Addendum #2

Project: 20250274 - IN083 CAMPUS CENTER - REPLACE BUILDING LIGHTING CONTROLS

Date: February 12, 2026

SHEET NUMBER:
3 of 6

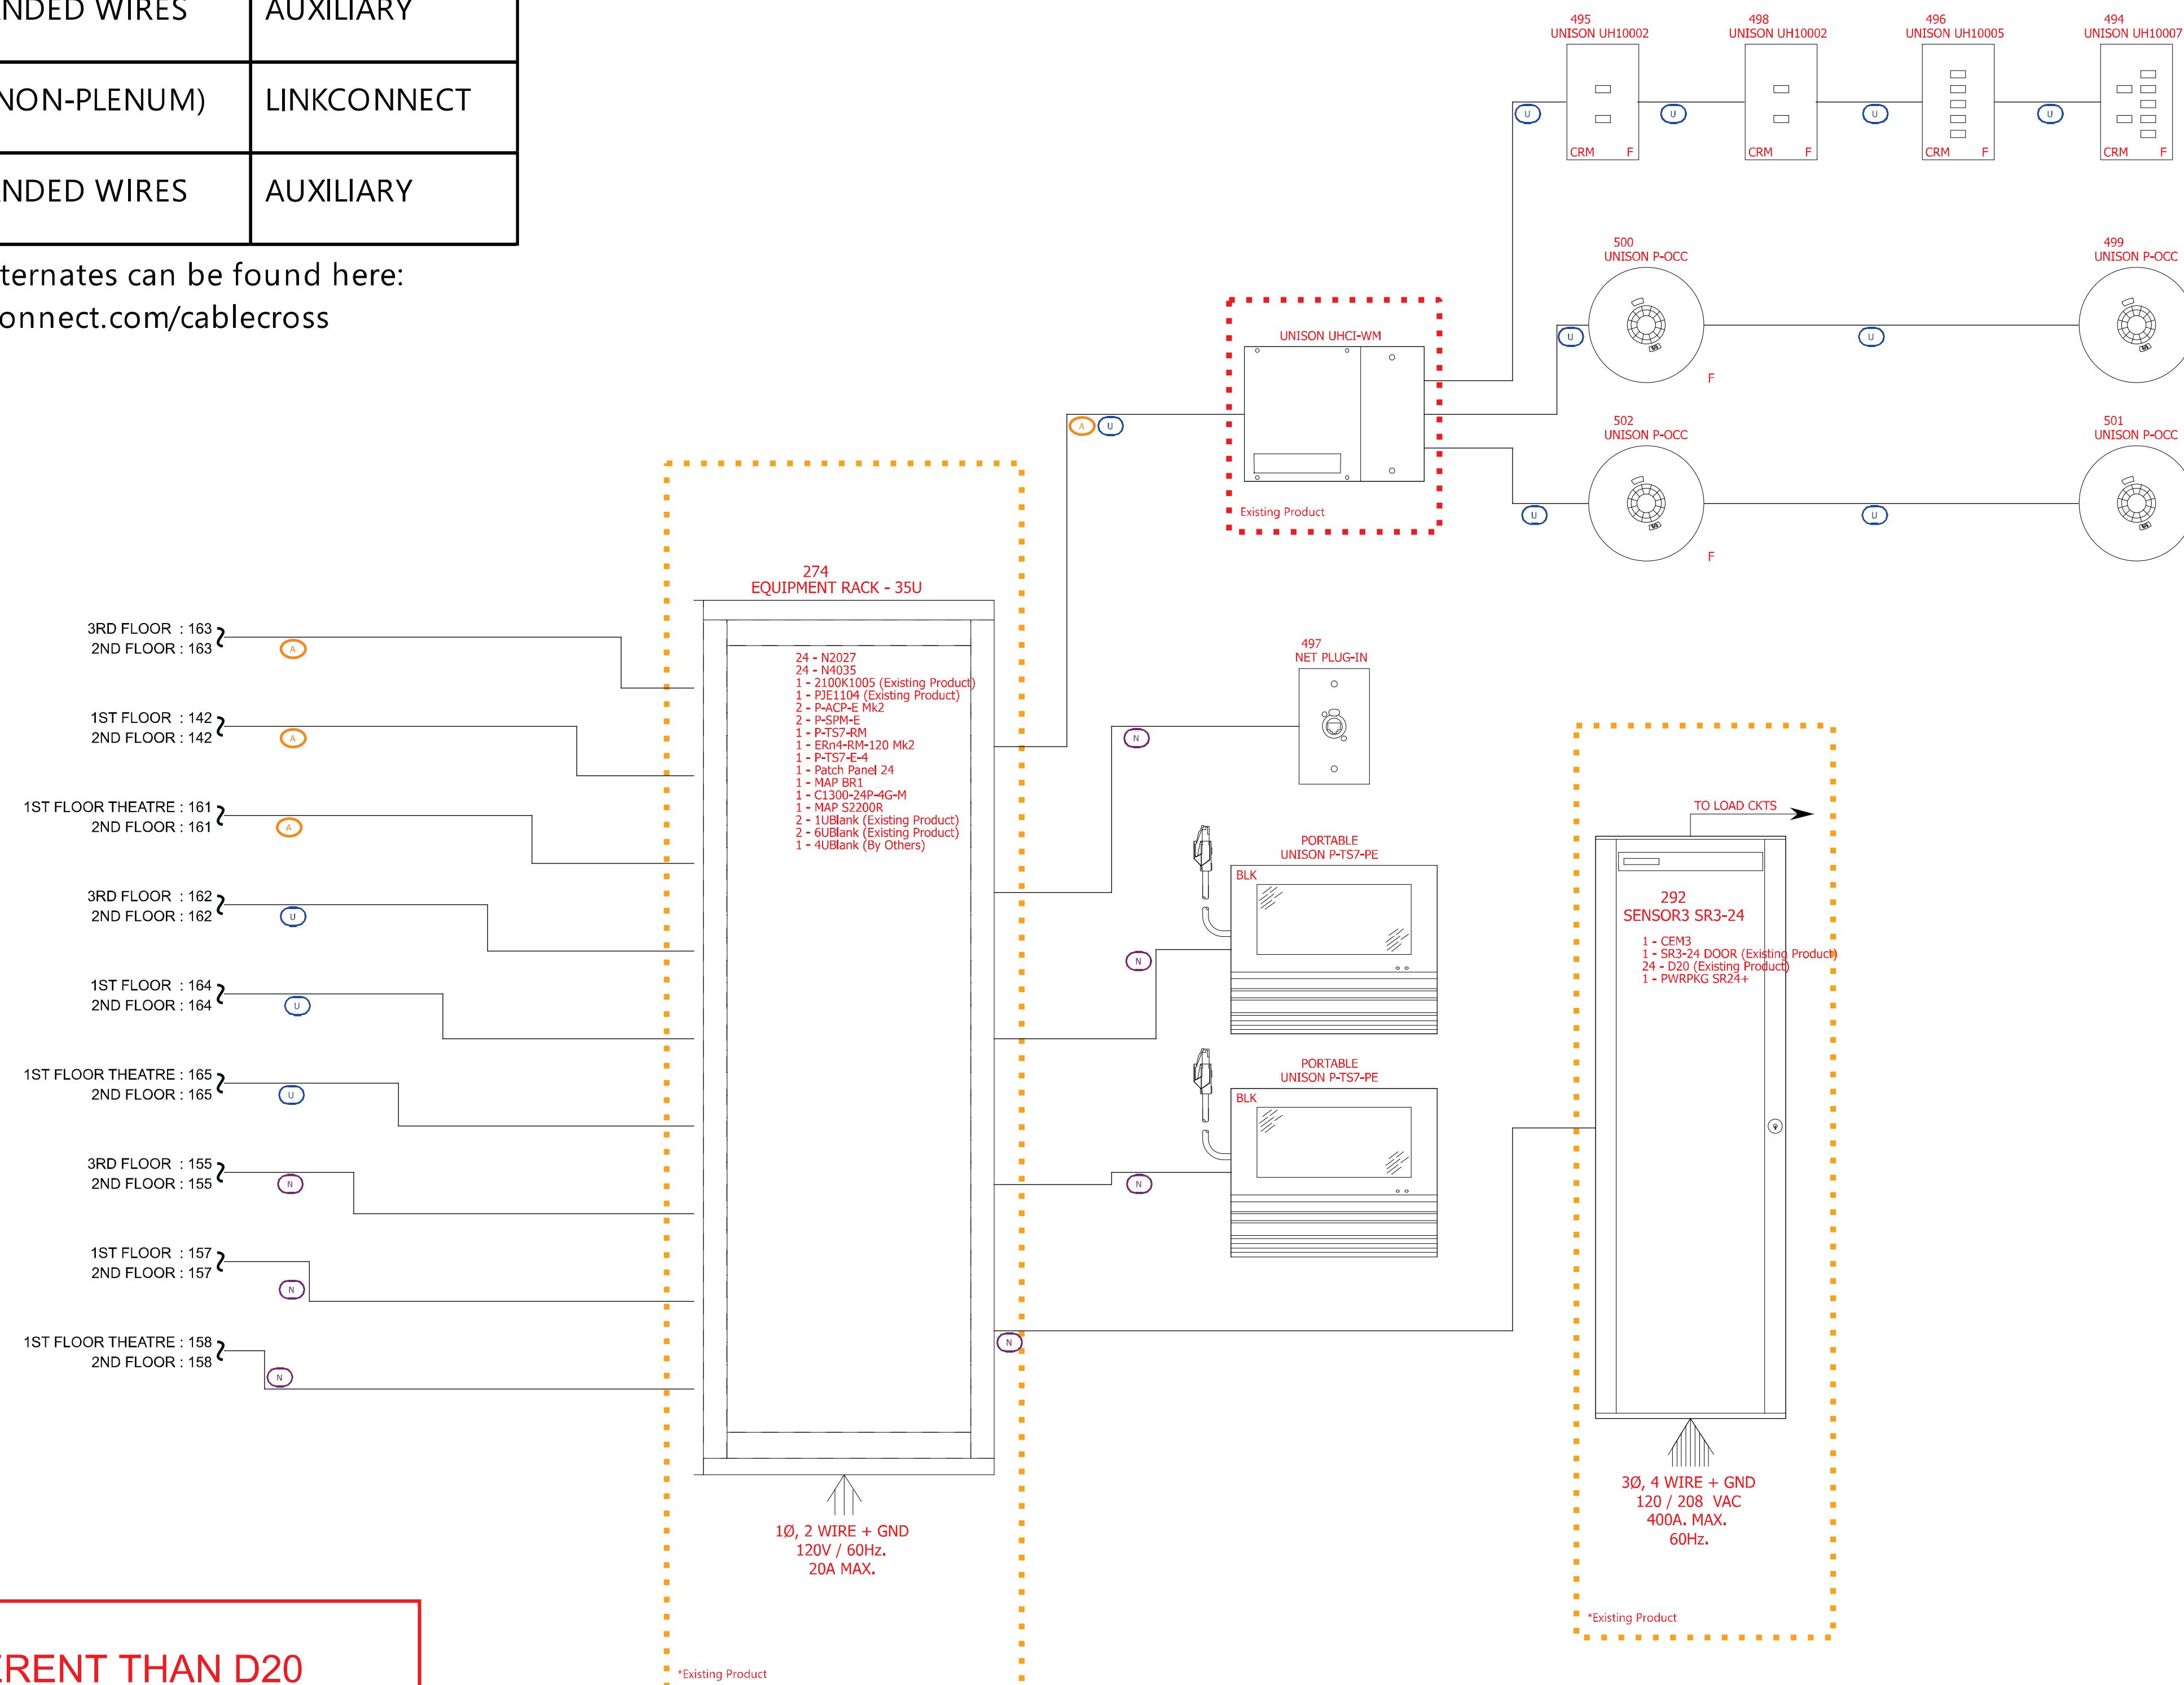
NOTE:
MODULES MAY BE DIFFERENT THAN D20
EXISTING UHCI TO BE J-BOX FOR "U" CABLE

SHEET NUMBER:
4 of 6

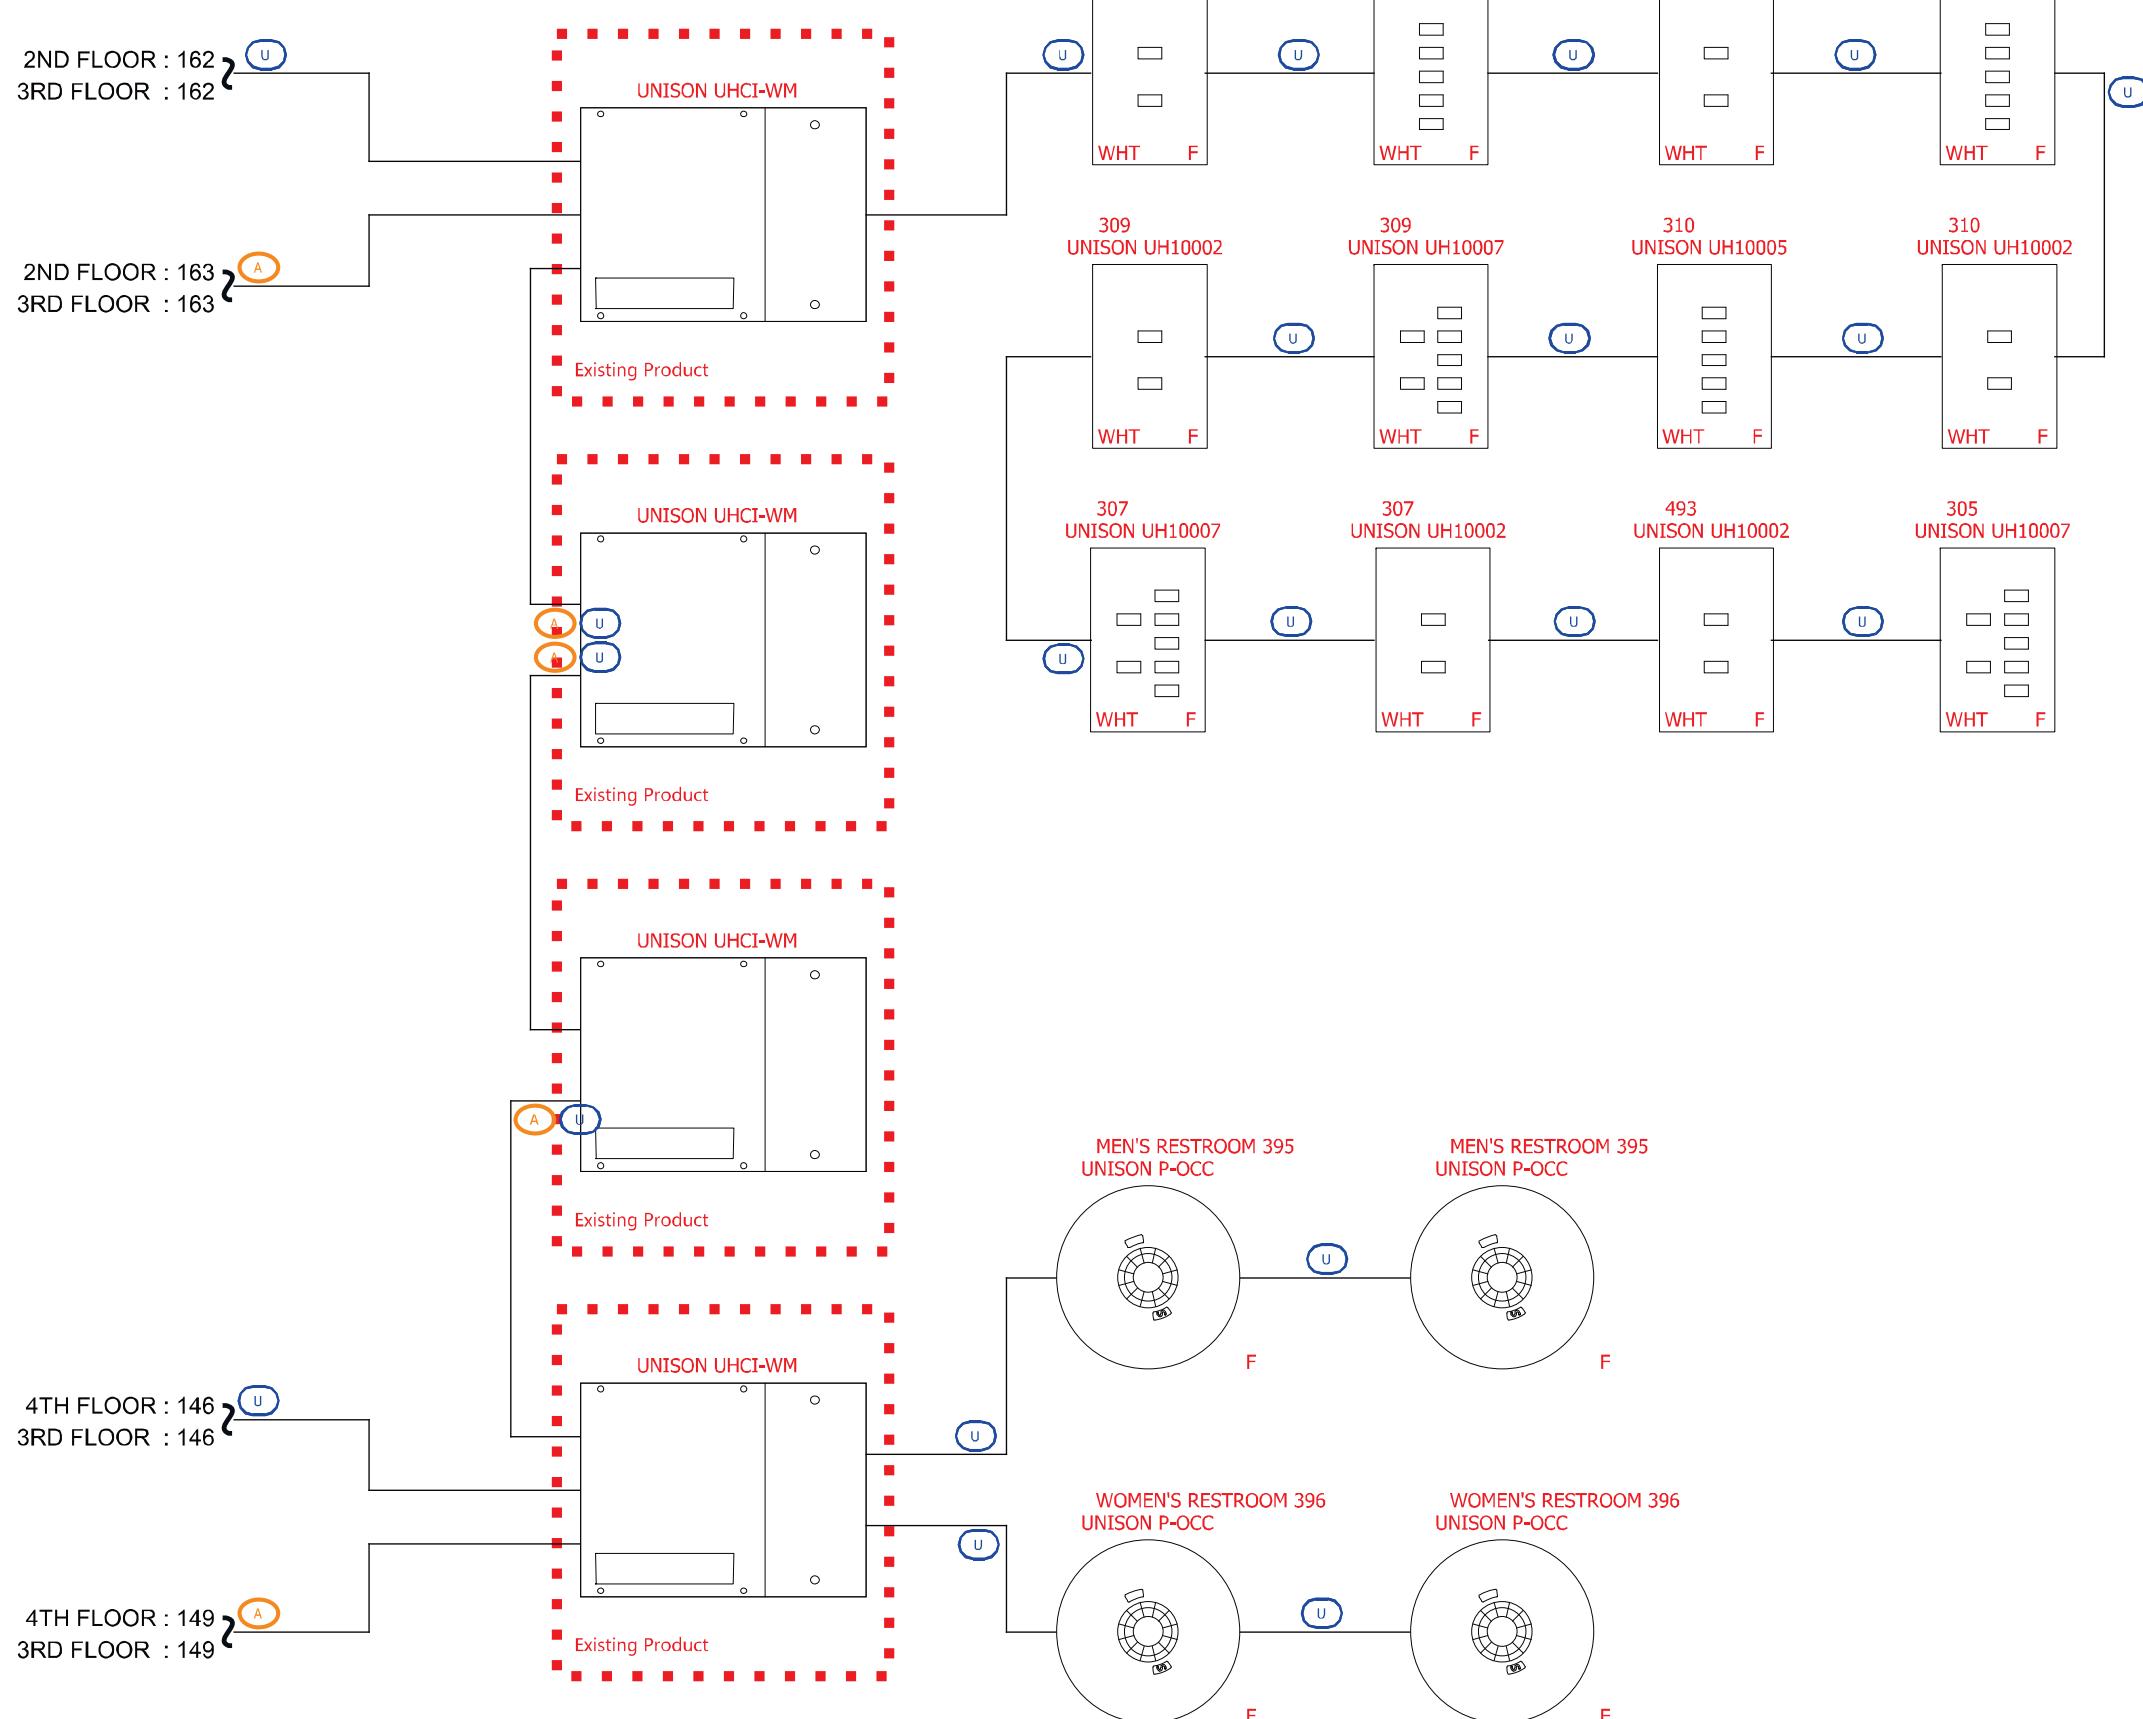
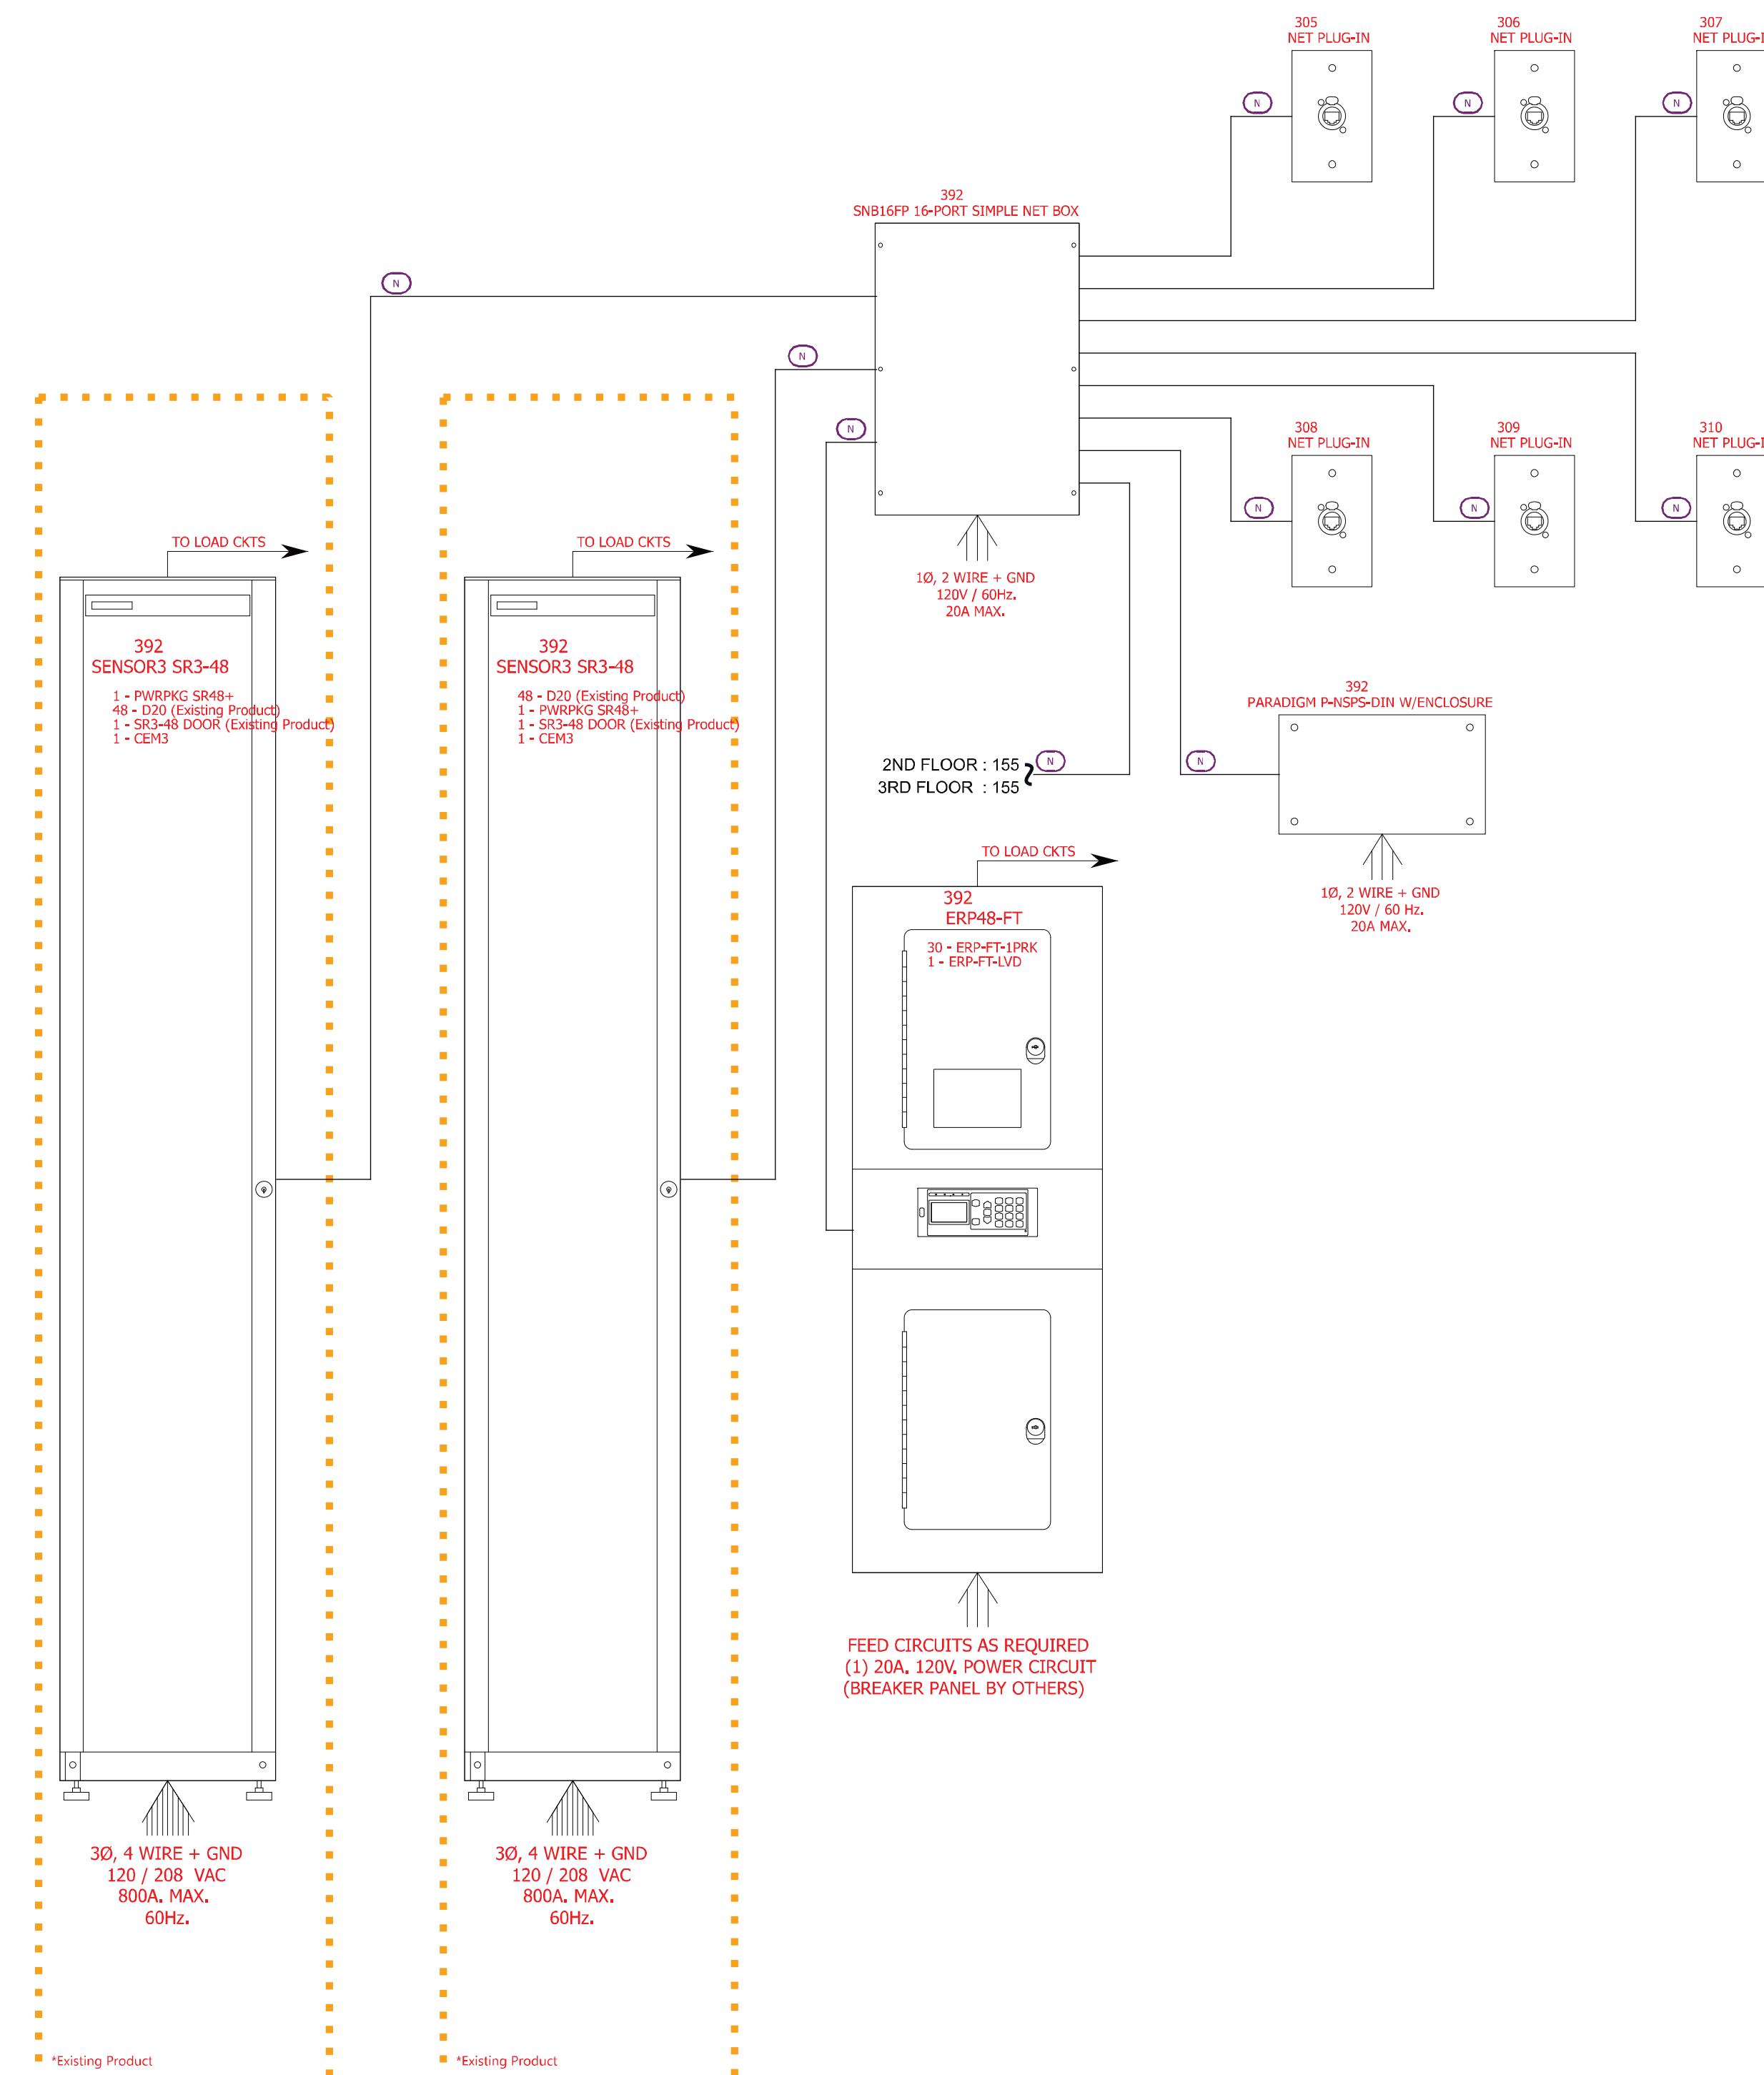
**NOTE:
MODULES MAY BE DIFFERENT THAN D20
EXISTING UHCI TO BE J-BOX FOR "U" CABLE**
